Newcastle Inner City Bypass – Rankin Park to Jesmond

Modification report: additional construction compounds

Submissions report

September 2021

Figure 6.1
Peatties Road - heritage sites

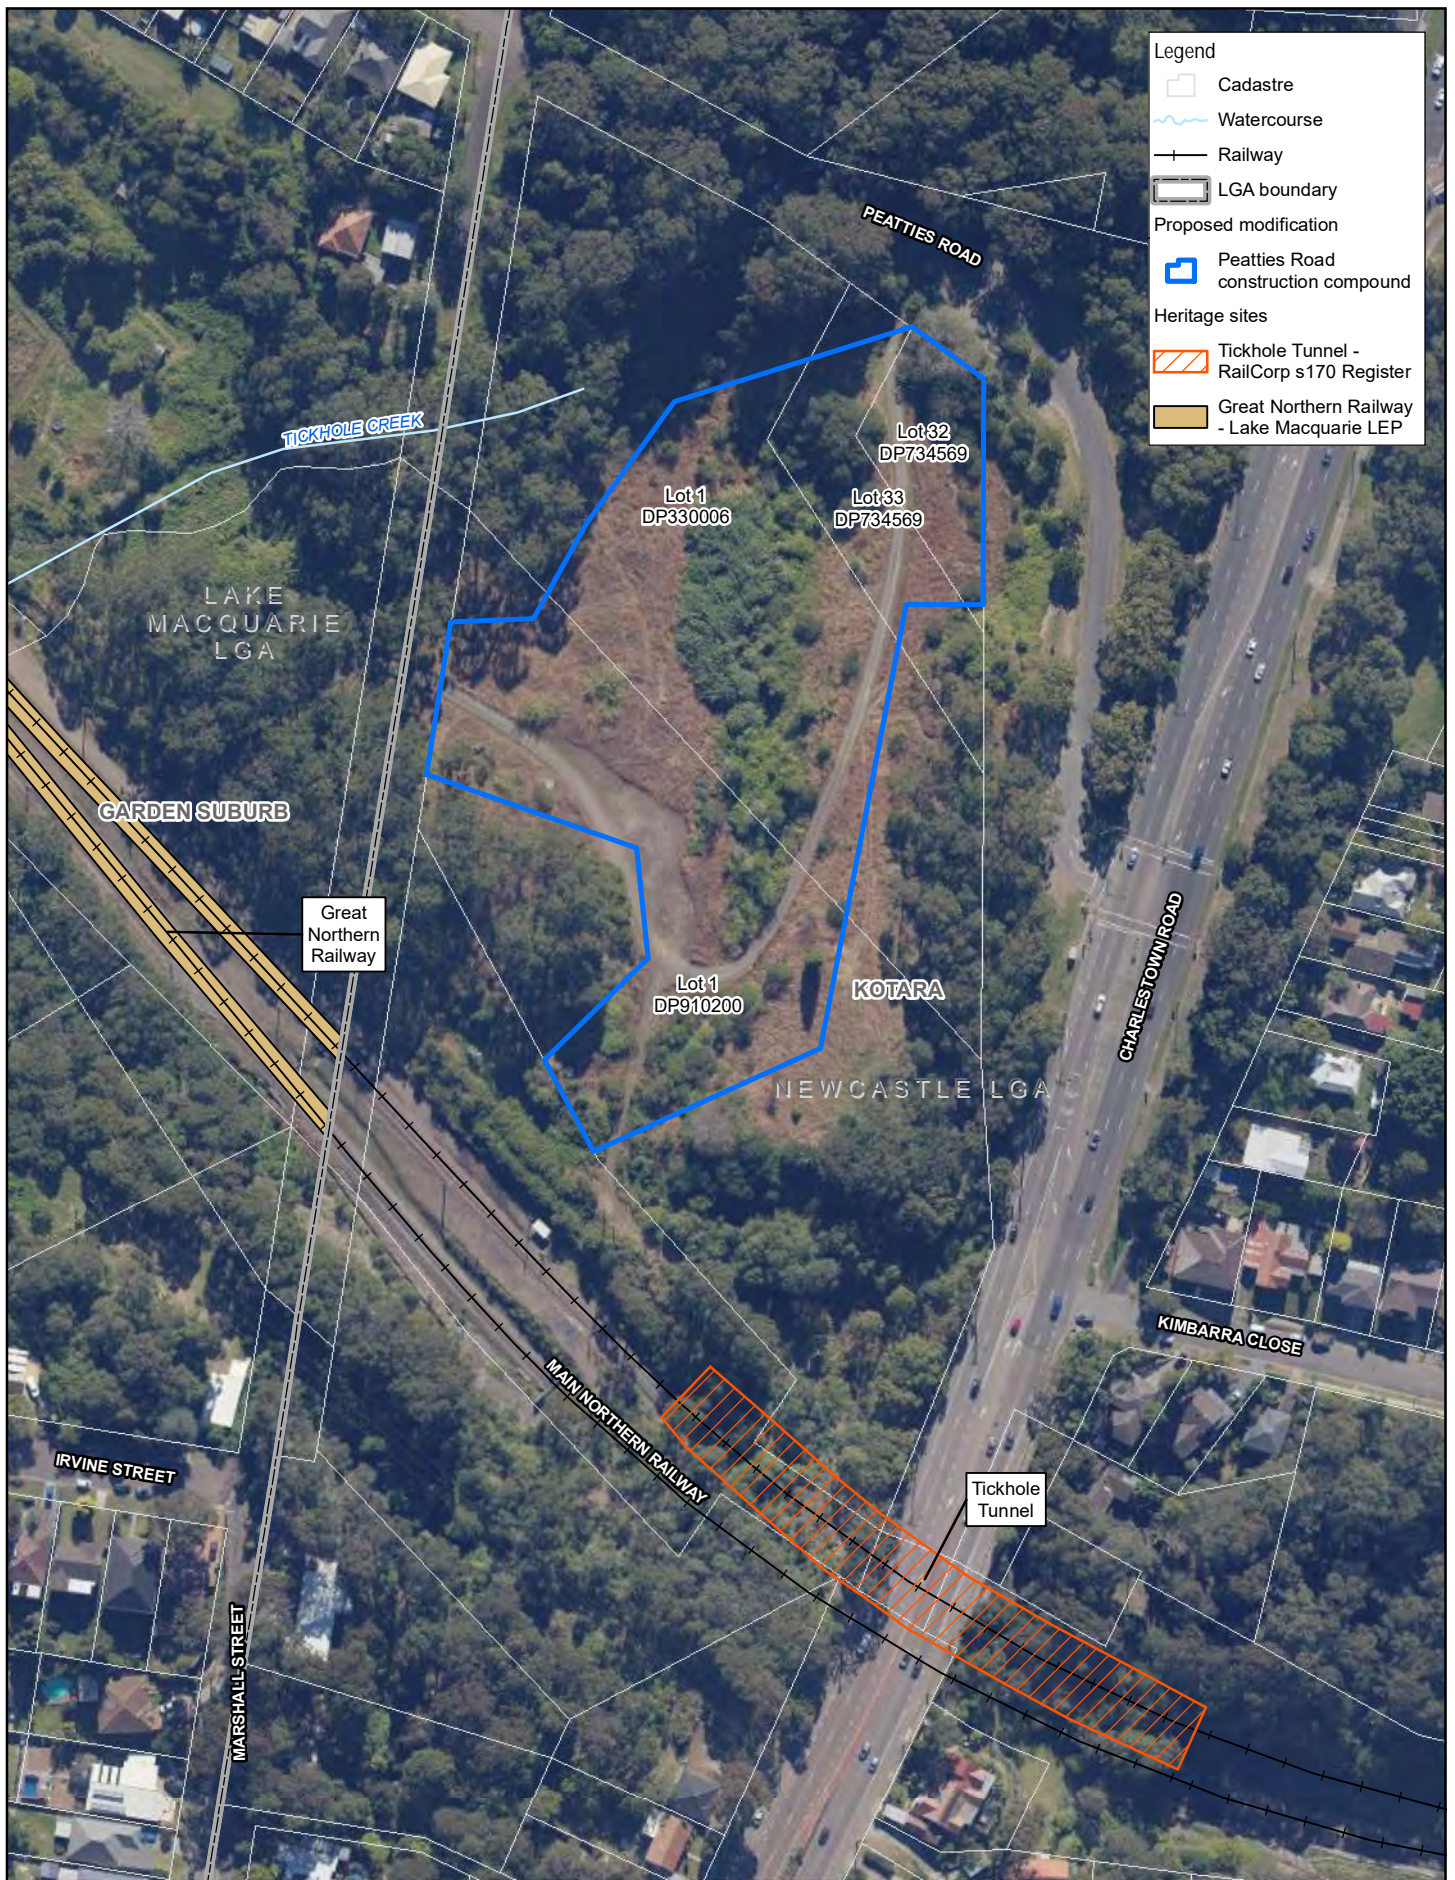
- City of Newcastle identified that the Astra Street site would not be available for use
- Potential impacts to Council infrastructure surrounding the proposed compound sites
- Department of Planning Industry and Environment (DPIE), Biodiversity Conservation Division, asked for clarification on the extent of flora survey at the Peatties Road site and how *Maunderia triglochoides* has been considered.

- Tickhole Tunnel which has historical significance at a local level, is located on the northern-leg of the Main Northern Rail Line and passes under Charlestown Road. At the western portal Tickhole Tunnel is about 65 metres from the Peatties Road compound.

While Tickhole Tunnel is outside the 35 metre buffer distance for heritage structures at risk from vibratory rolling, due to the nature of this structure and importance for operation of the Main Northern Rail Line an additional mitigation measure has been recommended **Error! Reference source not found.**
